March 15, 2016

PND No. 102029.12

Subject: Portage Cove Harbor Expansion Project – Section 408 Permit

Figure 1. Alternative 1 - PCHE Wave Barrier – 95% Design with Gap (Length 633 feet)

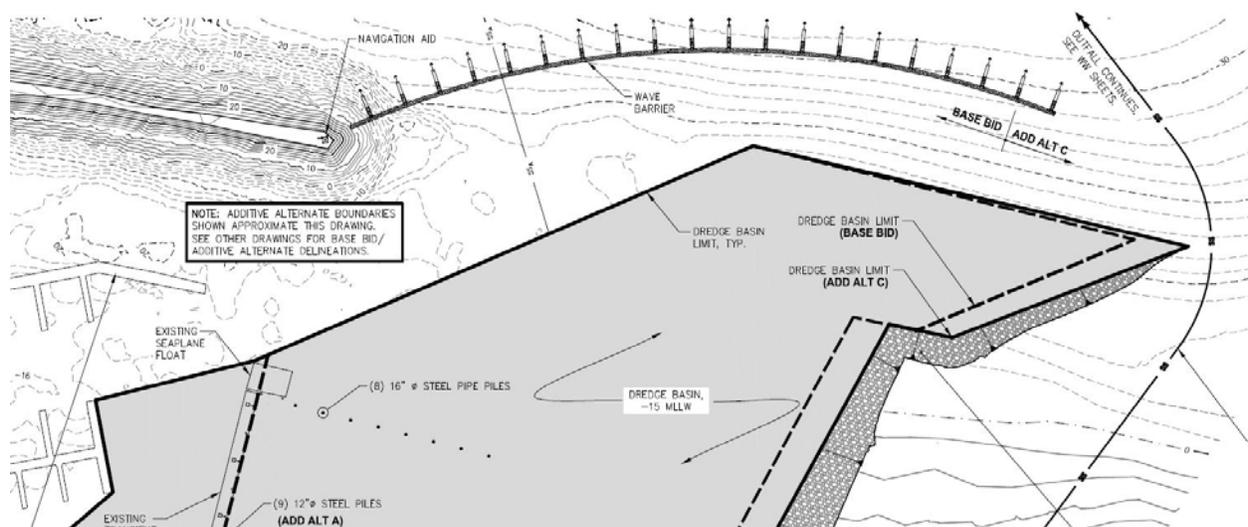
1. Potential wave transmission through the gap between the wave barrier and crest of the existing breakwater will cause larger waves inside the harbor than designed for. On Sheet 5.04 in the 95% design review submittal, there should not be a gap between the wave barrier and the crest of the existing breakwater.

A design alternative that closes the gap with an extended wave barrier is presented in the enclosed drawings. PND agrees that a design without a gap will reduce the transmitted wave energy. However, it is questionable whether the added cost of approximately \$290,000 (excluding armor rock) has sufficient value. Wave numerical modeling and diffraction diagram calculations (enclosed) indicate that the transmitted wave energy is acceptable, based on discussions with the harbormaster and local officials. In addition to the reduced construction cost, the benefits of the gap include improved circulation and fish passage, and reduced armor rock displacement forces near the wave barrier. The Haines Borough would like to discuss this issue further with the USACE and the Alaska DOT&PF before deciding whether to include this added length of wave barrier in the design.

A
5.02 **TYPICAL SECTION**

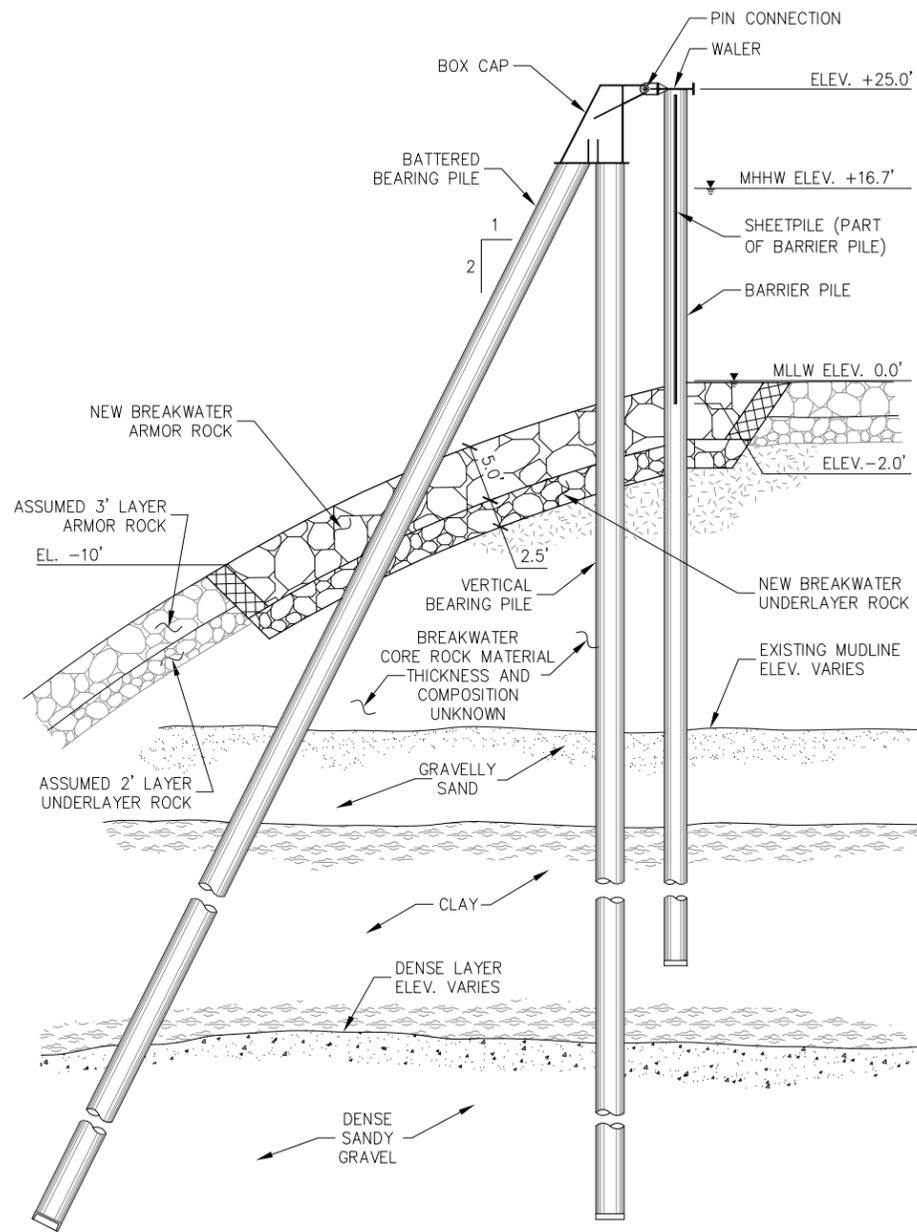
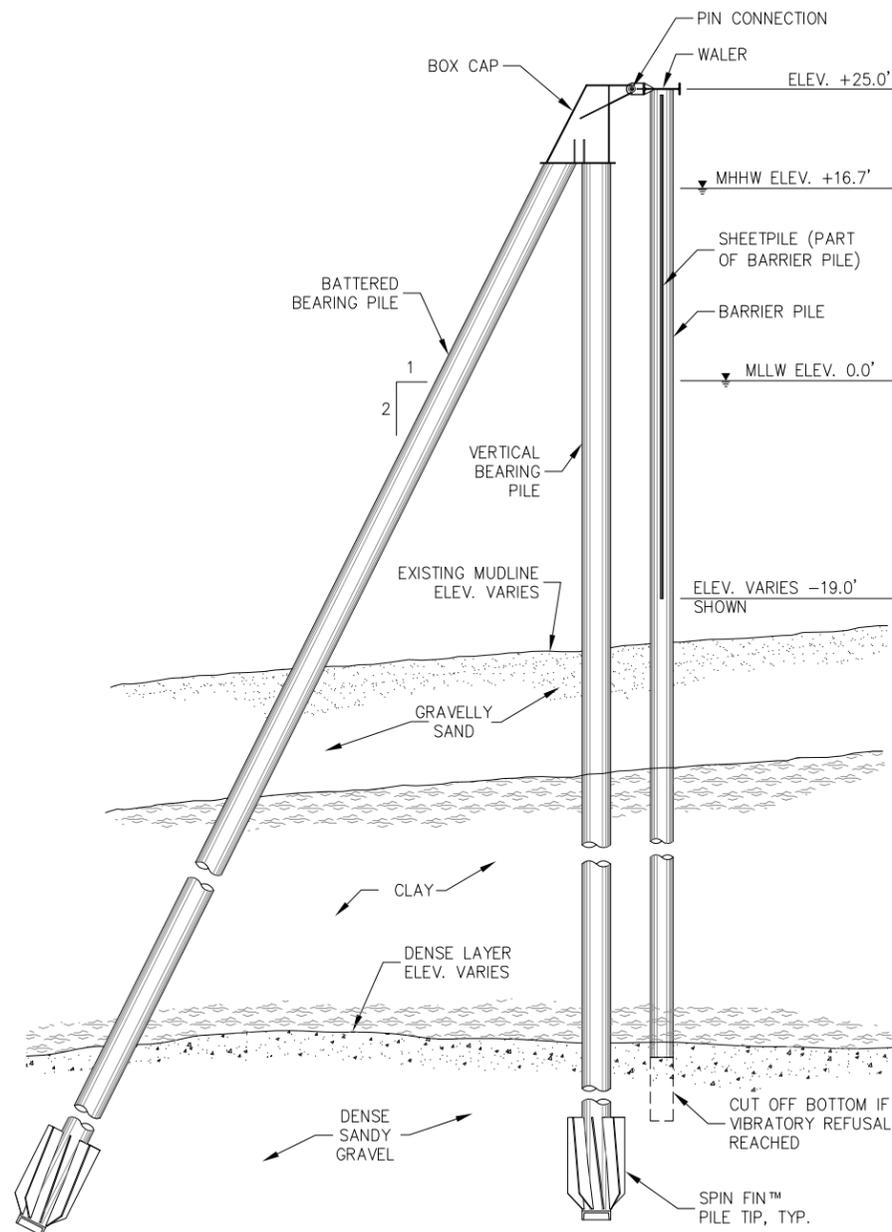
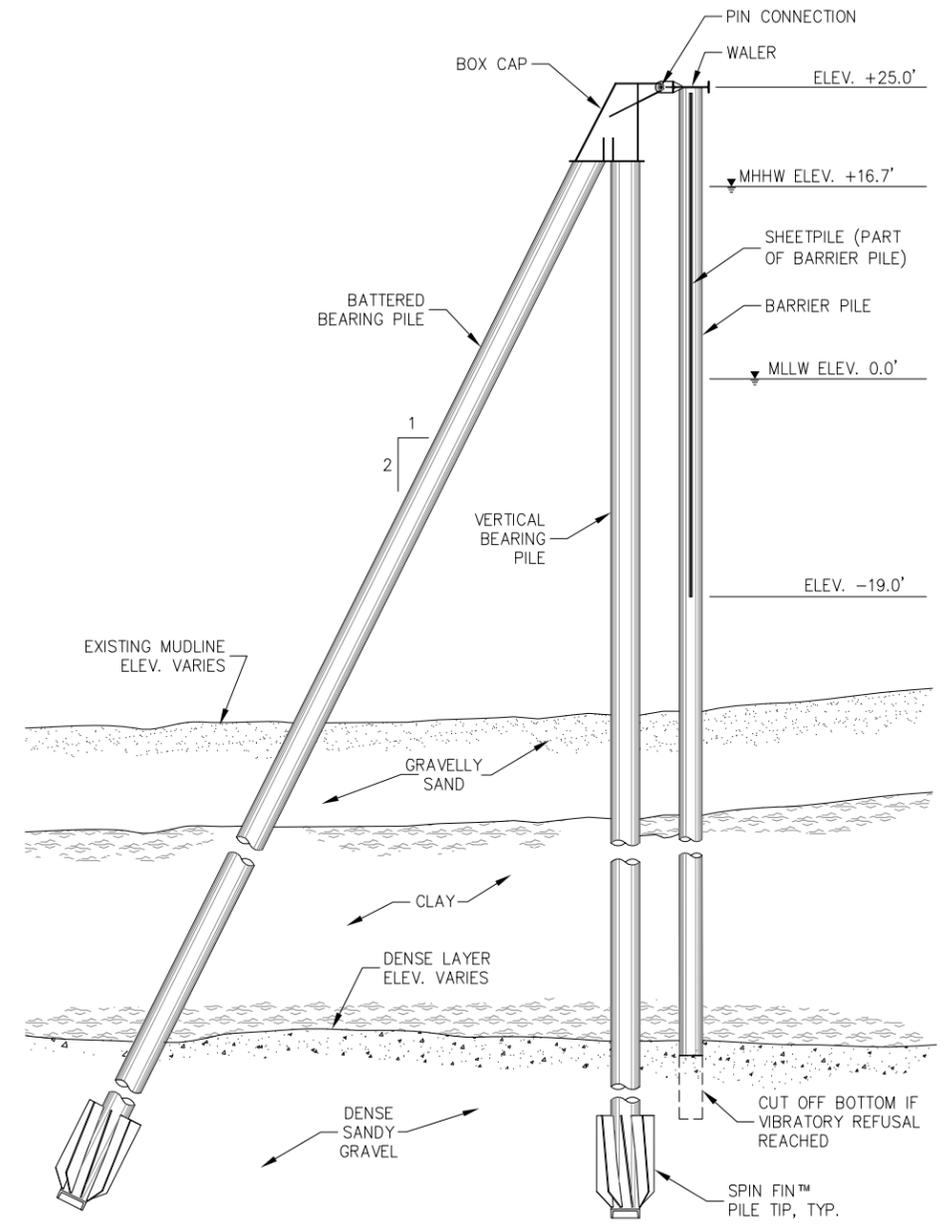
4. Please submit cross section drawings for review that show the redesigned two layers of armor rock at 2500 lbs or 3500 lbs (based on site investigation), two layers of "B" rock, and core that will fit within the current breakwater neat lines. It must also detail the transition from the existing armor rock configuration to the new armor stone size, starting at a minimum of 25 feet from the wave barrier on the Portage Cove side of the breakwater.

The proposed wave barrier extension and rubble mound breakwater armor rock design is shown on the attached drawings. The design includes a median armor rock size of W50= 2,500 pounds. The underlayer rock size is 250 pounds.

The attached drawings include plan, cross-section and details of the proposed design. The typical section shows a conventional 3 layer slope protection design, with armor rock, underlayer rock ("B" rock), and core rock.

SHEET TITLE:
**SUGGESTED CONSTRUCTION
SEQUENCE**

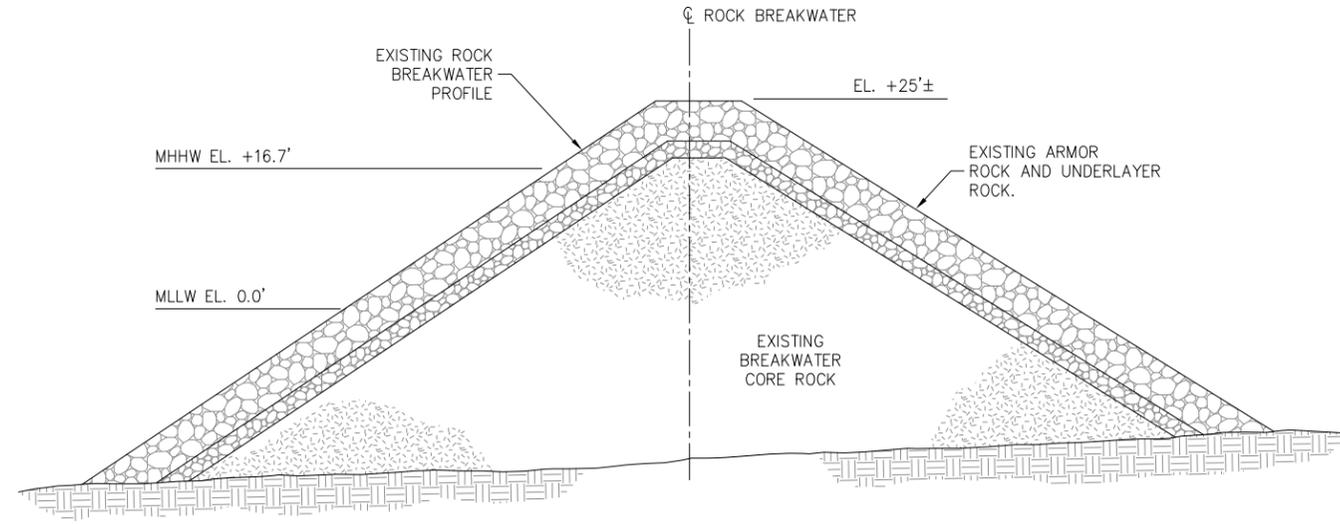
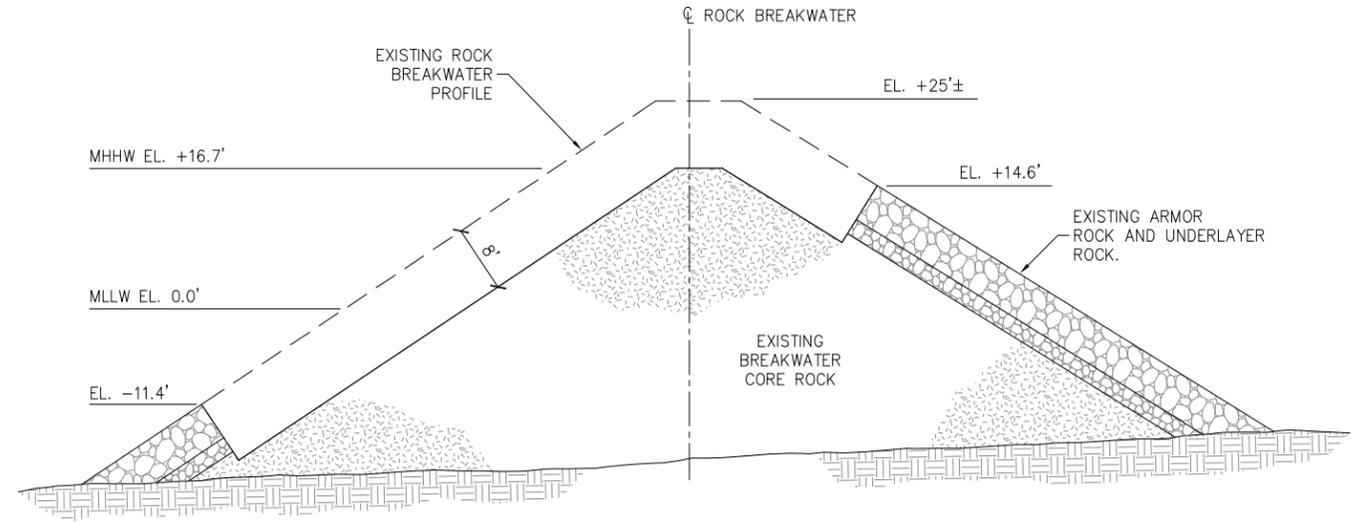
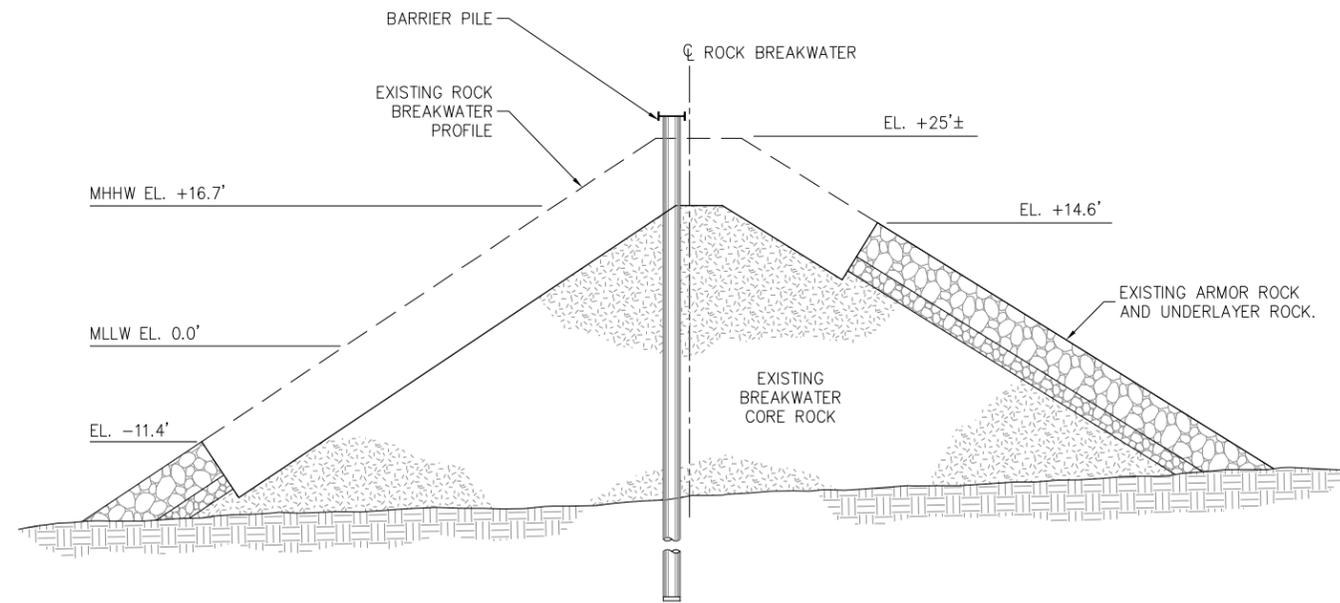
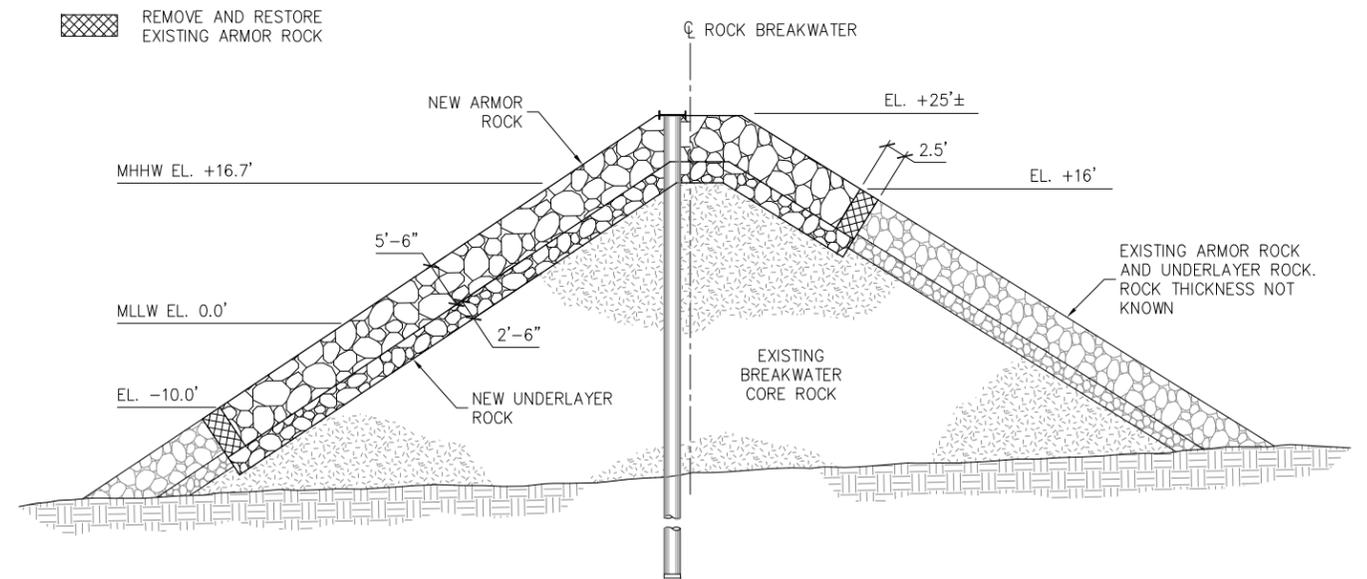
5.1 Provide a detailed construction sequence for the planned wave barrier wall connection to the existing breakwater, involving excavation within the breakwater, installation of piles and barrier wall elements, and reconstruction of the breakwater nose.

Attached is a drawing showing the recommended construction sequence. The existing armor rock and underlayer rock will be removed within the limits indicated and replaced with larger rock. The new rock will fit within the existing breakwater neat lines. The total volume, and weight, of rock at the existing breakwater will not change significantly.

Project		SPCHE Rubble Mound Stability Analysis	
Analysis Description		End of Construction	
Drawn By	SH	Company	PND Engineers, Inc.
Date	2/22/2016, 12:11:25 PM	File Name	Existing Breakwater EOC.slim

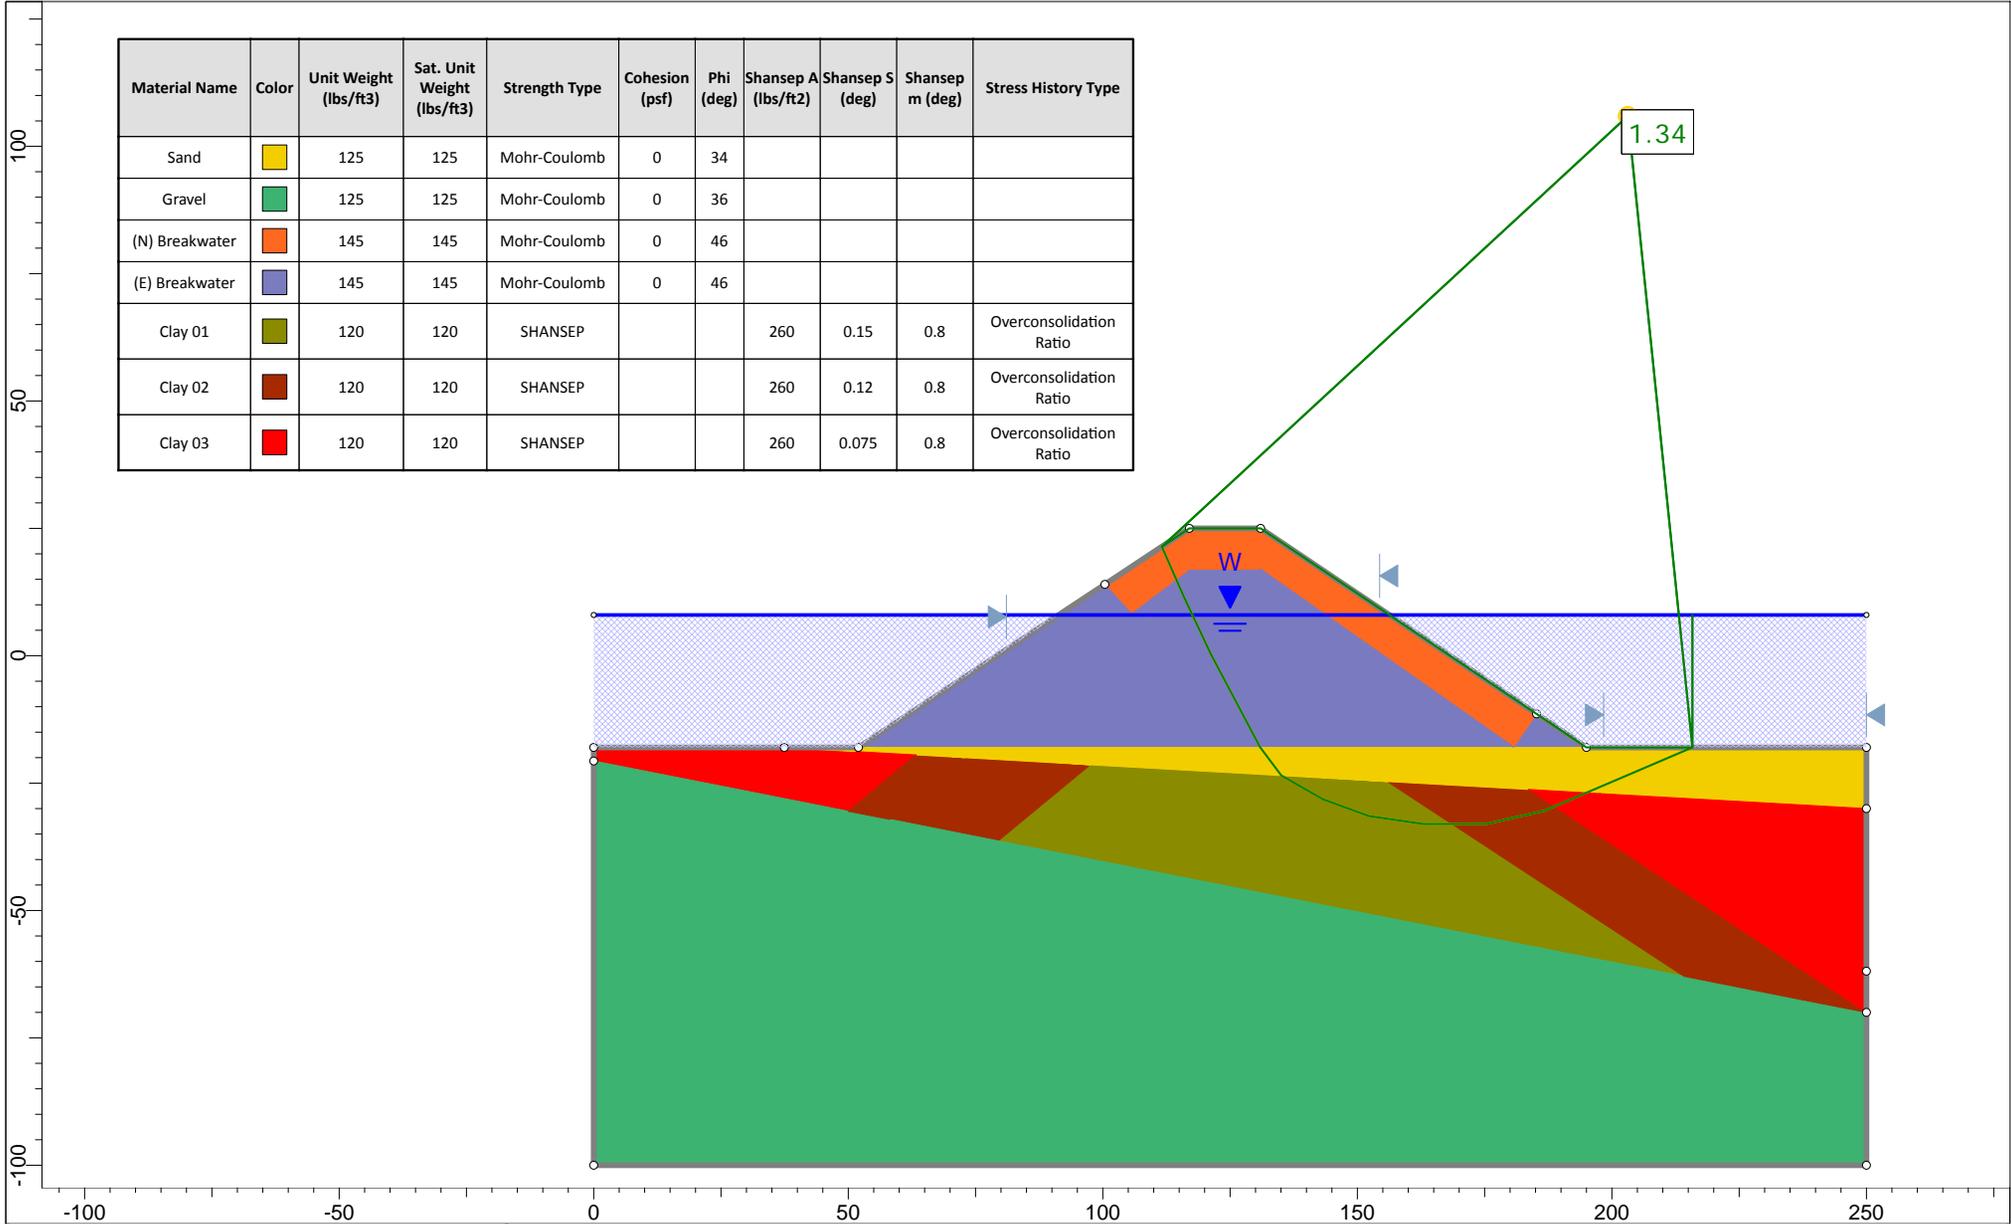
5.3 Perform a slope stability analysis to evaluate post-construction stability of the breakwater, considering pile driving and reconstruction of the breakwater nose. Post construction condition of the breakwater should be at least a factor of safety of 1.3 against slope failure as determined in accordance with Corps of Engineers criteria.

As discussed in the enclosed memo, the added wave barrier will improve the stability of the existing rock breakwater. Post-construction the tip of the rock breakwater will have a factor of safety greater than 1.3. Some distance from the new wave barrier, the existing rock breakwater factor of safety will remain unchanged post-construction.

PND determined the EOC FS to be 1.34 and the results are presented in the attached Figure. The results and conclusion of the analysis are that a required FS of 1.3 is achieved therefore the existing breakwater is deemed stable for the temporary condition of installation of the piles and reconstruction of the armor rock.
